Planning application A/114/18/PL

RE: PLANNING APPLICATION N^O A/114/18/PL FOR A 70 BED NURSING HOME TO PROVIDE PALLIATIVE AND ADVANCED DEMENTIA CARE, (LOCATED ON SITE BOUNDED BY WATER AND DAPPERS LANES ANGMERING, WEST SUSSEX).

**RE: PLANNING APPLICATION N^o A/114/18/PL FOR A 70 BED NURSING HOME
TO PROVIDE PALLIATIVE AND ADVANCED DEMENTIA CARE, (LOCATED
ON SITE BOUNDED BY WATER AND DAPPERS LANES ANGMERING, WEST
SUSSEX).**

EXISTING SEWAGE NETWORK
4" DIAMETER PIPE

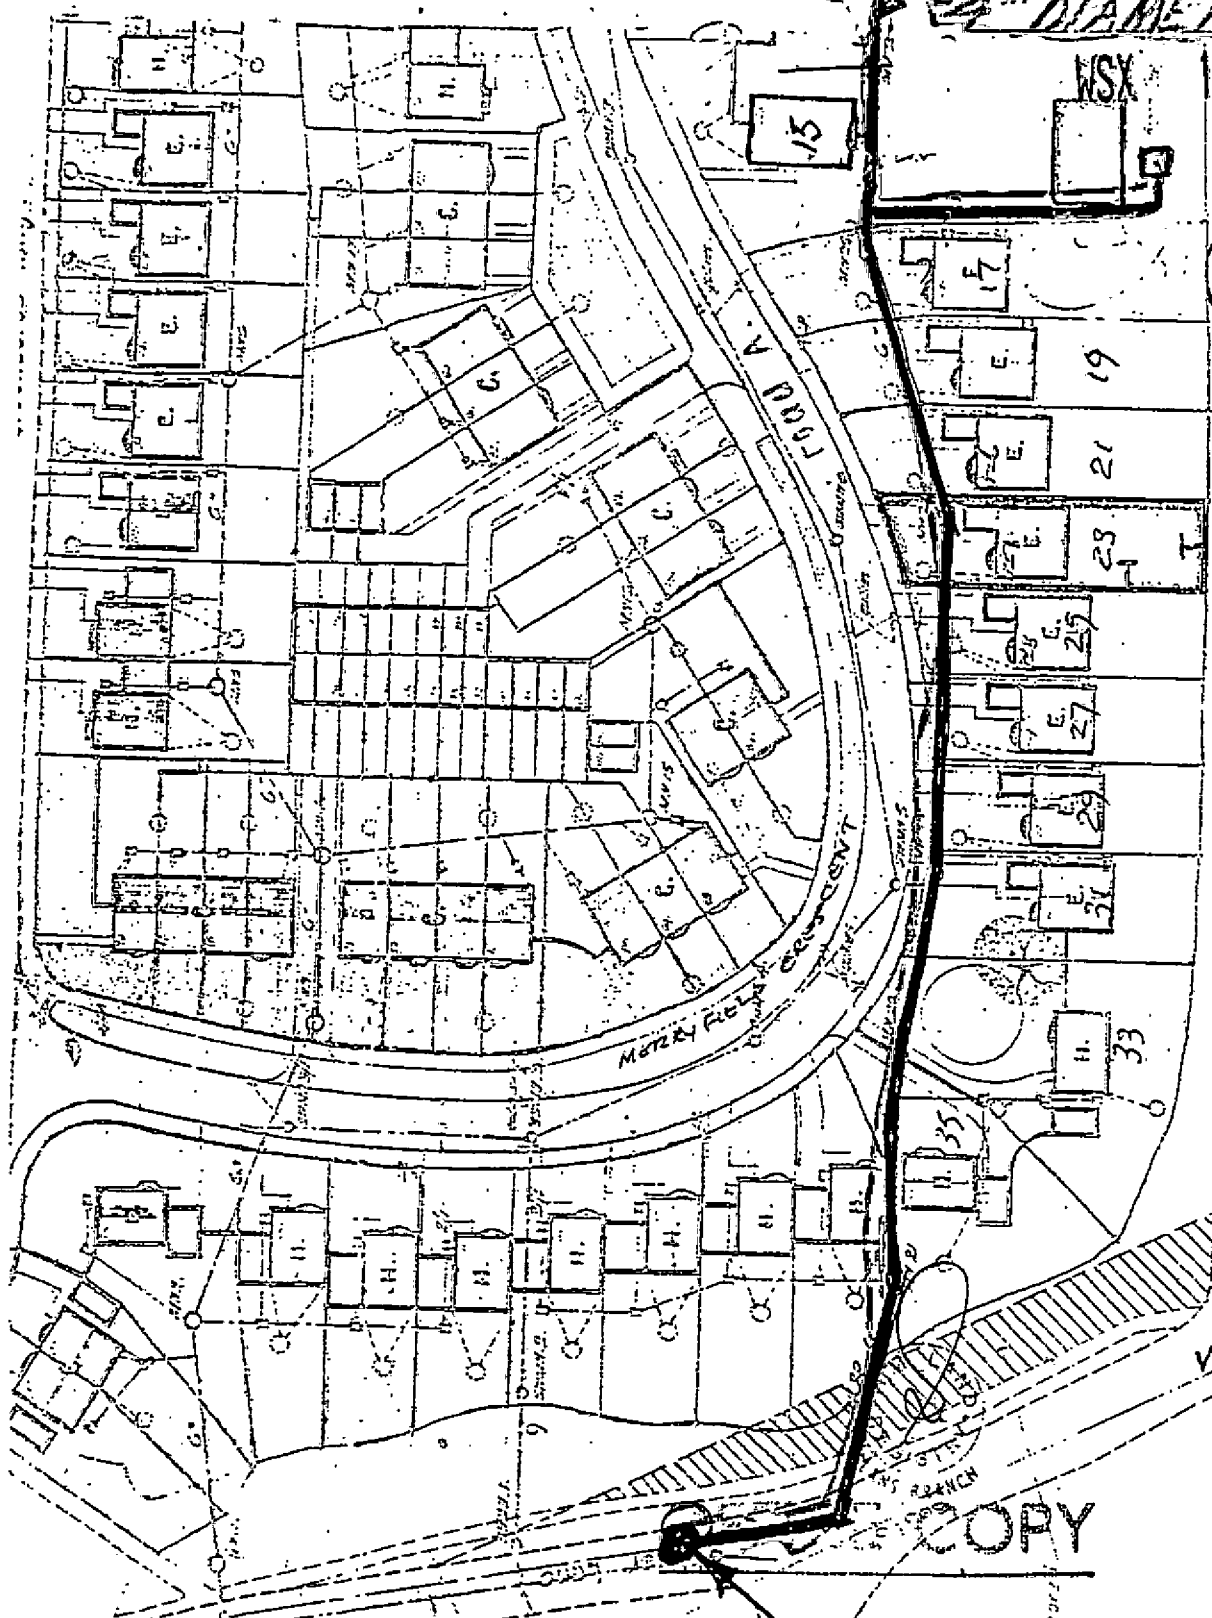
- i. THERE IS NO DRAINAGE INSTALLED IN DAPPERS LANE FROM "BROADLEES" TO WATER LANE.
- ii. THERE IS NO MAIN DRAINAGE GOING WEST IN WATER LANE UNTIL THE WATER LANE AND WEAVERS HILL JUNCTION AT WHICH POINT IN WATER LANE A SOUTHERN WATER MANHOLE COVER **REF N^O TO 070 425 01** IS LOCATED; **PLEASE REFER TO ATTACHED DRAINAGE ROUTE MAP ATTACHED HEREWITH. (ATTACHEMENT - ii).**

- iii. ATTACHED HERewith IS A LETTER FROM SOUTHERN WATER DATED 28TH JULY 2016 WHICH STATES **"ADDITIONAL OFF-SITE OR IMPROVEMENT TO EXISTING SEWERS WILL BE REQUIRED TO PROVIDE SUFFICIENT CAPACITY TO SERVICE THE PROPOSED DEVELOPMENT" (ATTACHMENT i)**
(NOTE:- 4" DIA SEWER PIPE RUNS UNDER FRONT GARDENS IN MERRYFIELD CRESCENT)
- iv. OVER THE LAST FIFTEEN MONTHS (15 MONTHS) OVERFLOWS OF RAW SEWAGE HAS OCCURRED IN MERRYFIELD CRESCENT AND WATER LANE DUE TO A LACK OF SEWER CAPACITY REQUIRING LONG PERIODS OF HOSING FRONT GARDENS AND DRIVEWAYS WITH MAINS WATER TO DILUTE RAW SEWAGE, CLEARLY THIS IS UNACCEPTABLE AND IS A SERIOUS HEALTH HAZARD.
